AGENDA PORTLAND PLANNING BOARD MEETING

- i. Major Site Plan and Subdivision; 385 Congress Street; Fathom Congress, LLC., Applicant. (estimated time 4:30 – 6:00 pm) The Planning board will hold a remote workshop to consider the first project phase of the Master Development Plan for 385 Congress St., approved by the Planning Board on August 9, 2022. The program for this phase includes an 11 story, 167,345 square foot building with 156 hotel rooms, nine upper-floor condominium units, structured and surface parking and a plaza for public use. The subject property is 2.26 acres and zoned B-3

To: Chair Stanley and Members of the Portland Planning Board
From: Zach Powell, Senior Planner
Date: October 21, 2022
Re: Herald Square (Phase 1 of 385 Congress Street Master Development Plan)
Applicant: Fathom Congress, LLC
Project ID: PL-002156-2022
Meeting Date: October 25, 2022

385 CONGRESS HOTEL | ENLARGED BUILDING ELEMENTS - HOTEL ENTRANCE

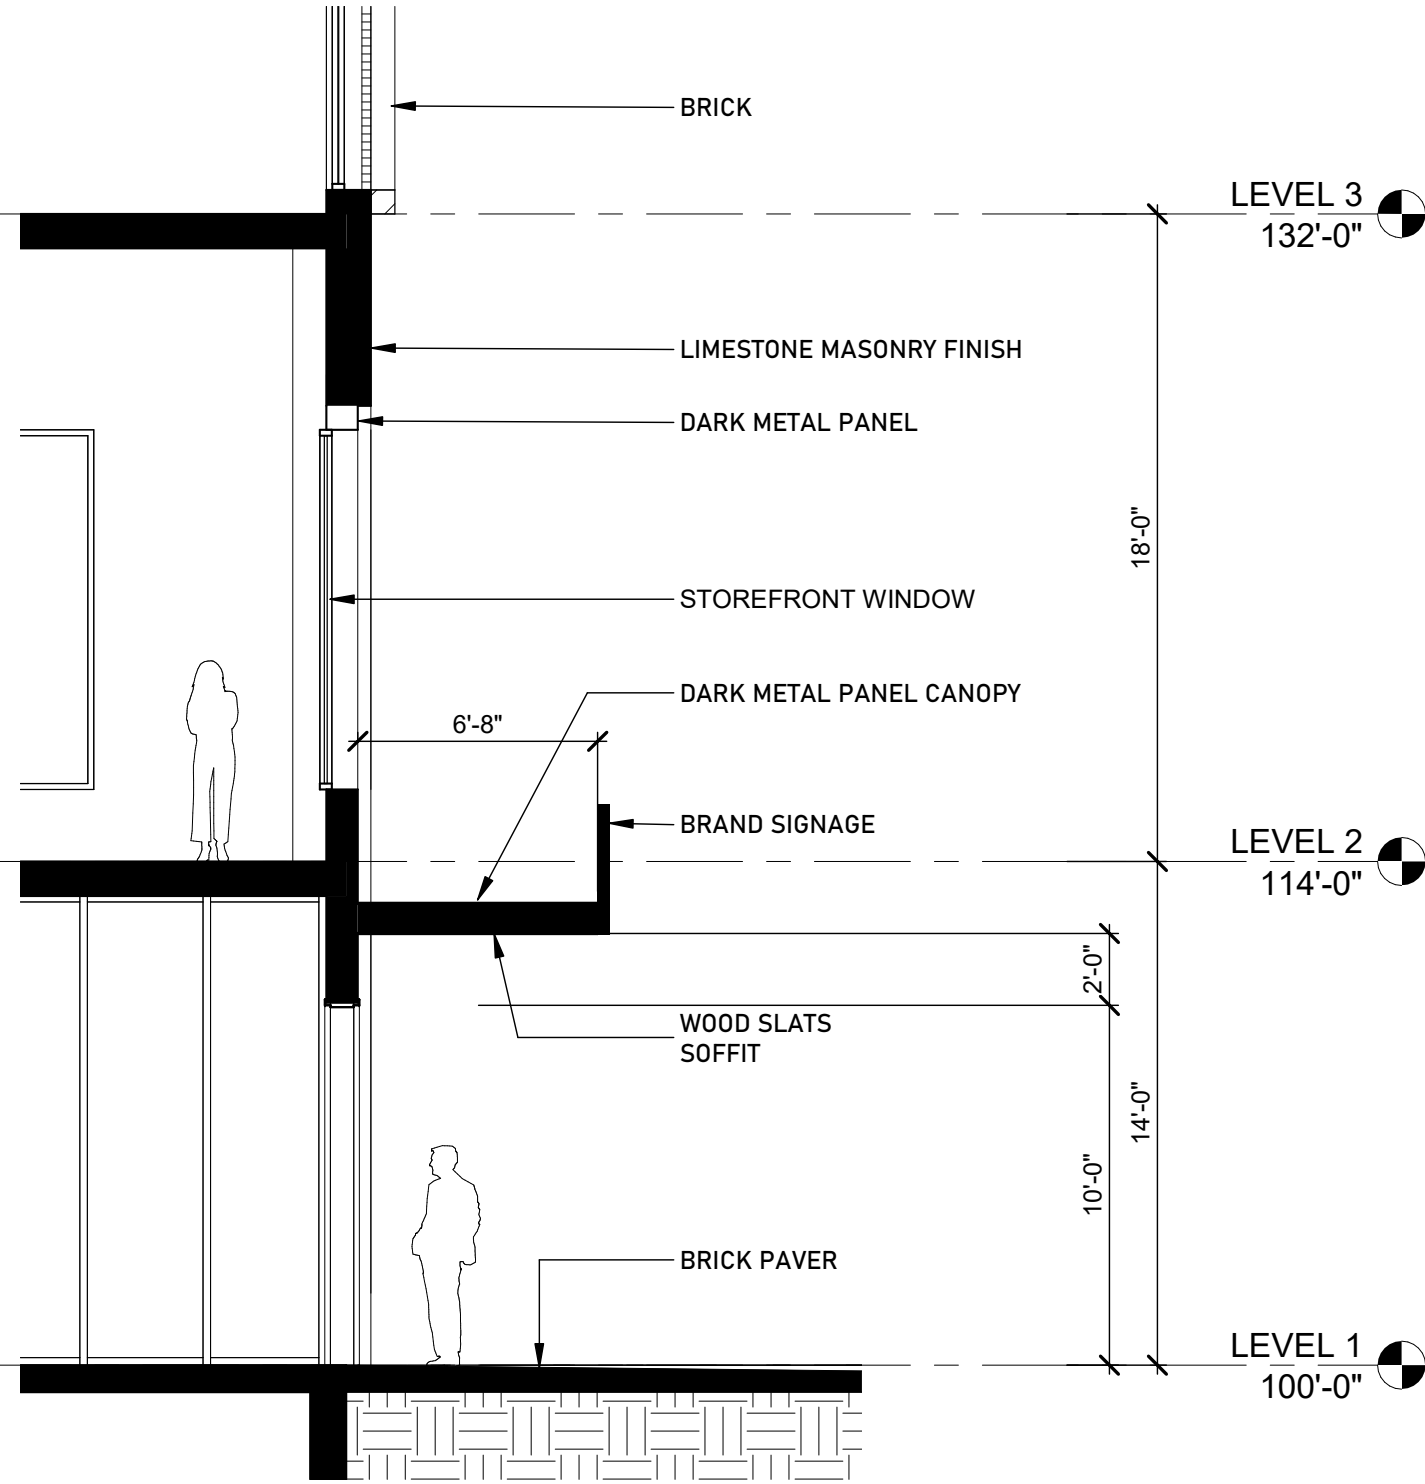
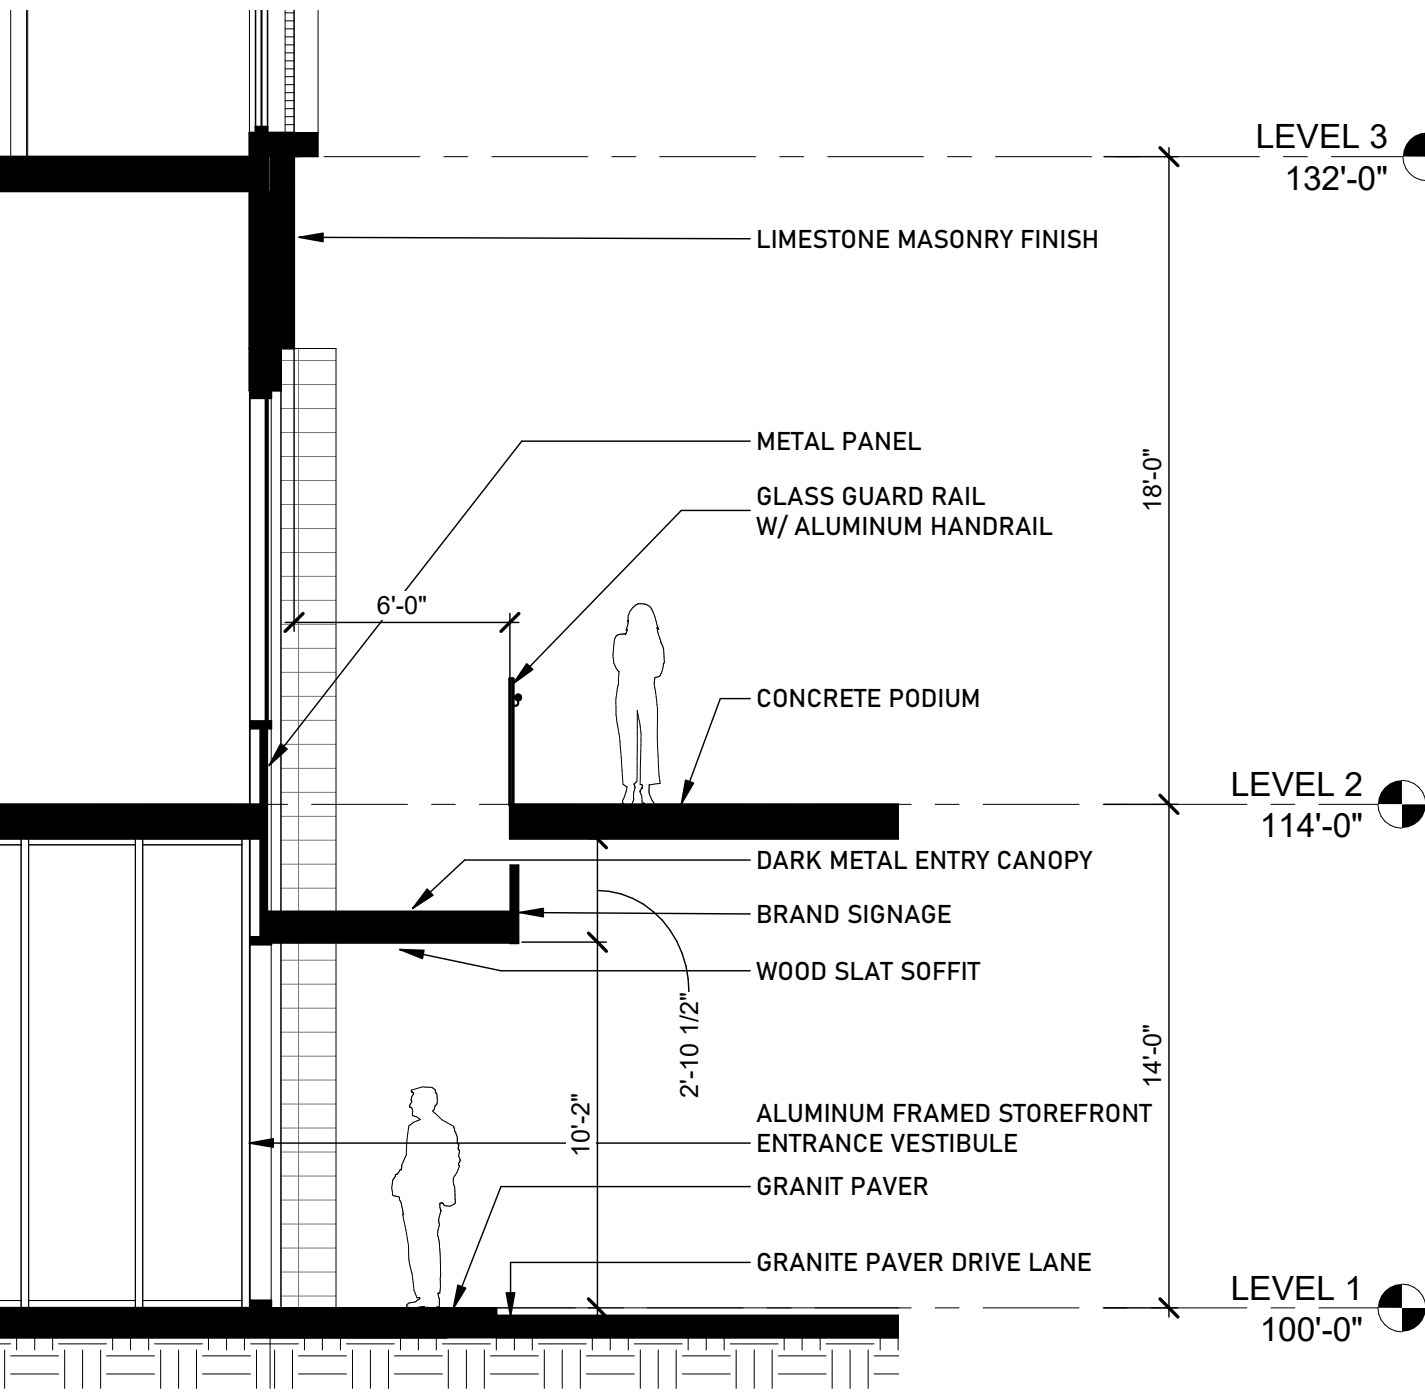
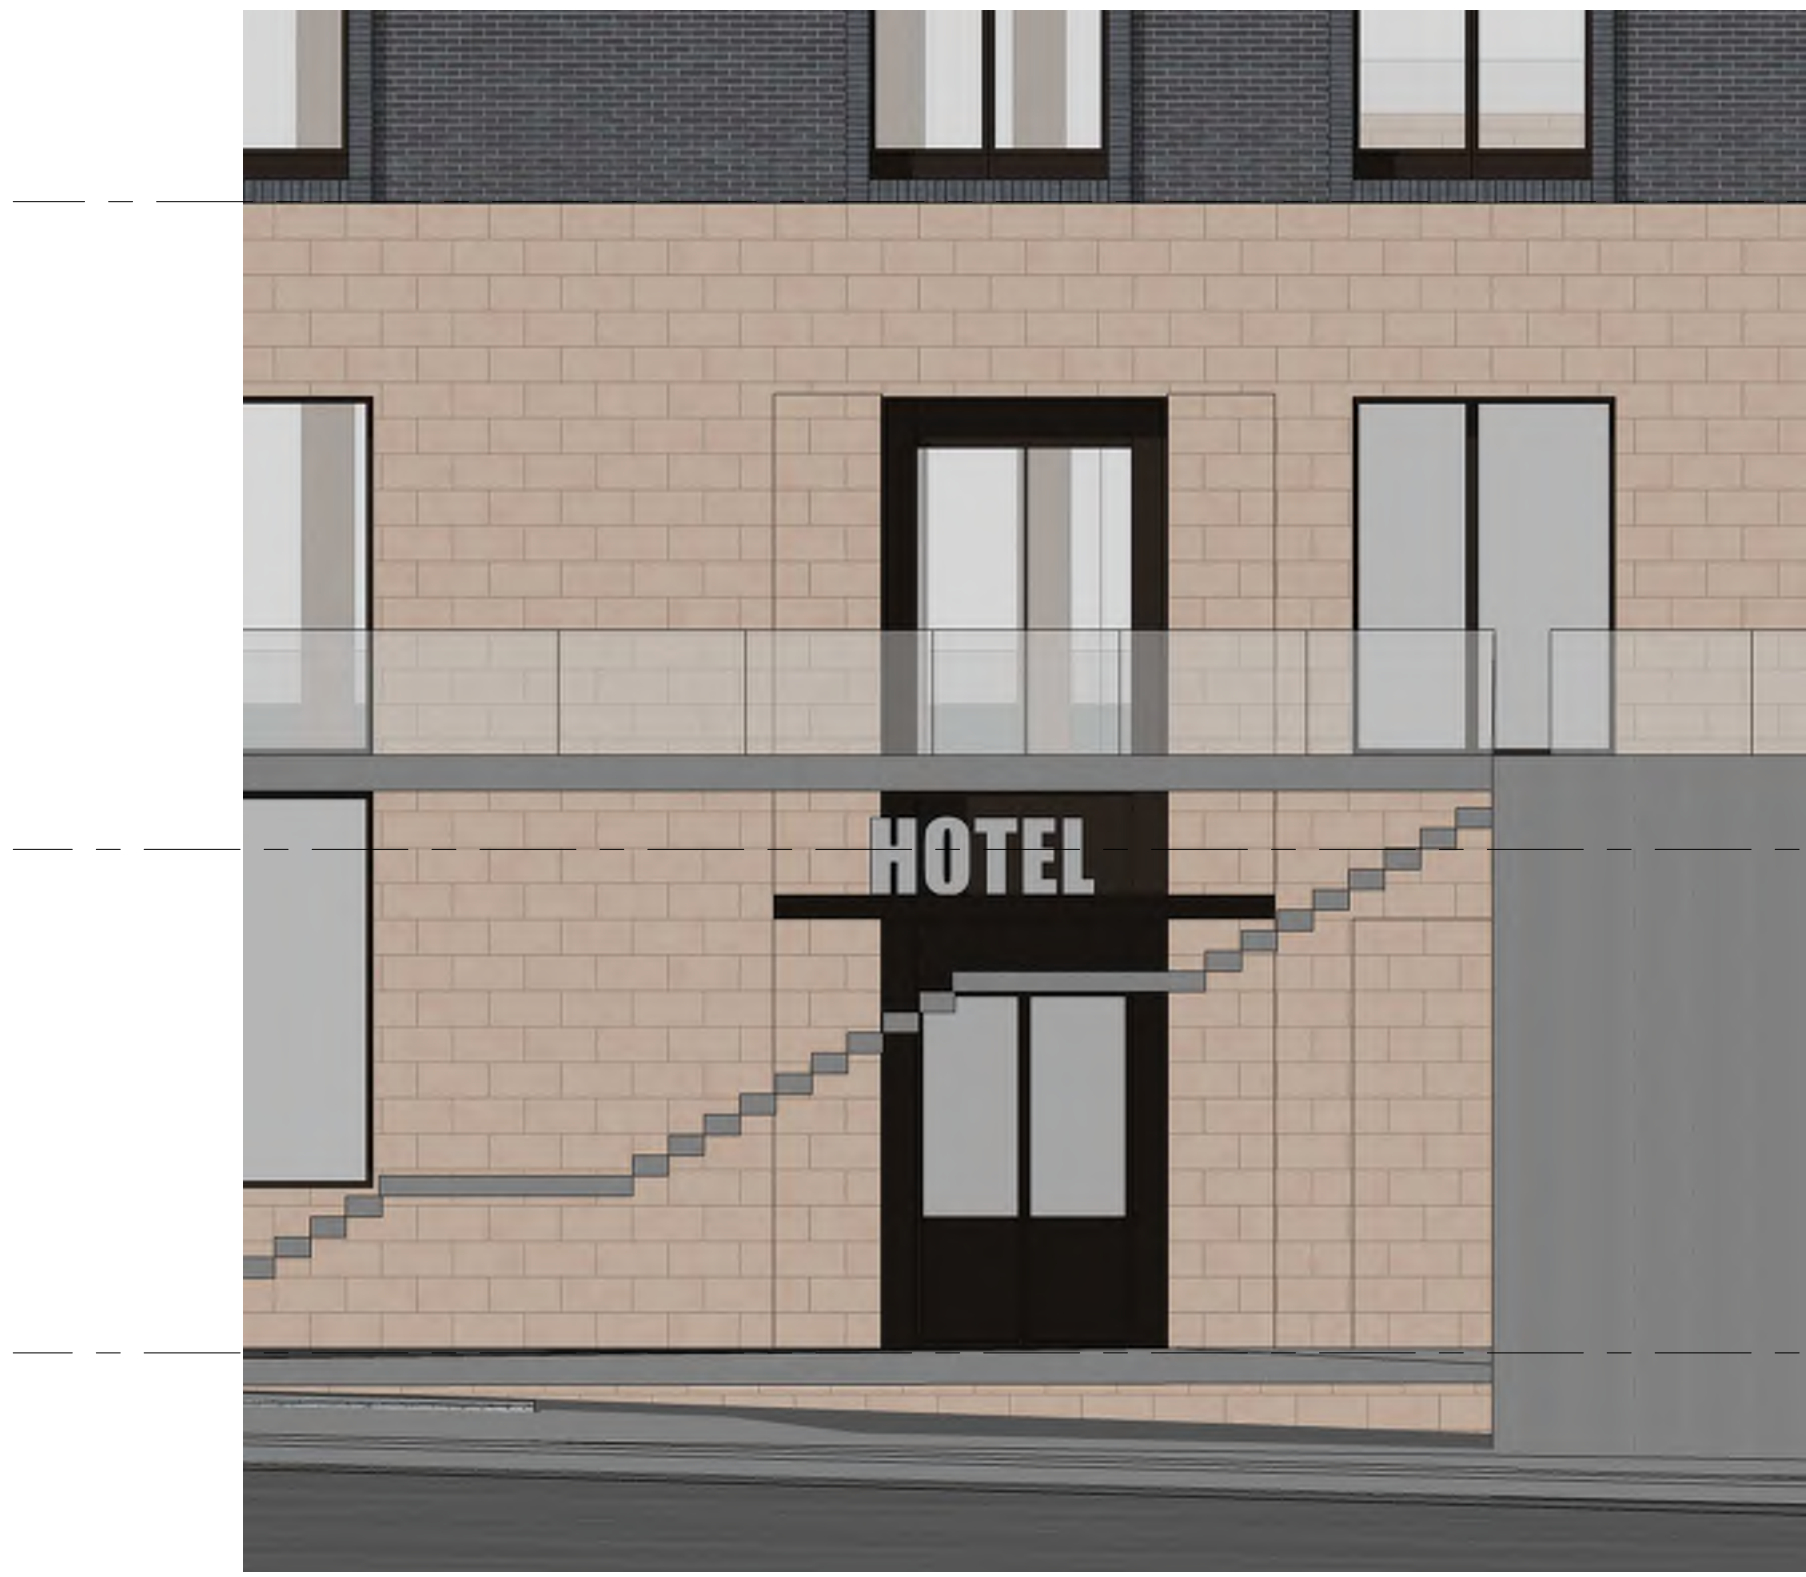
Staff Comment: The project site is located adjacent to a view corridor along Congress Street. Feedback from the MDP review resulted in the Applicant matching the front setback of the building along Congress Street with City Hall to provide more consistency in the street wall, which also provides additional viewshed benefits. Given that the proposed project does not propose expanding the building footprint into the City right-of-way, the proposed building design does not substantially obstruct the public view corridor and this standard is met.
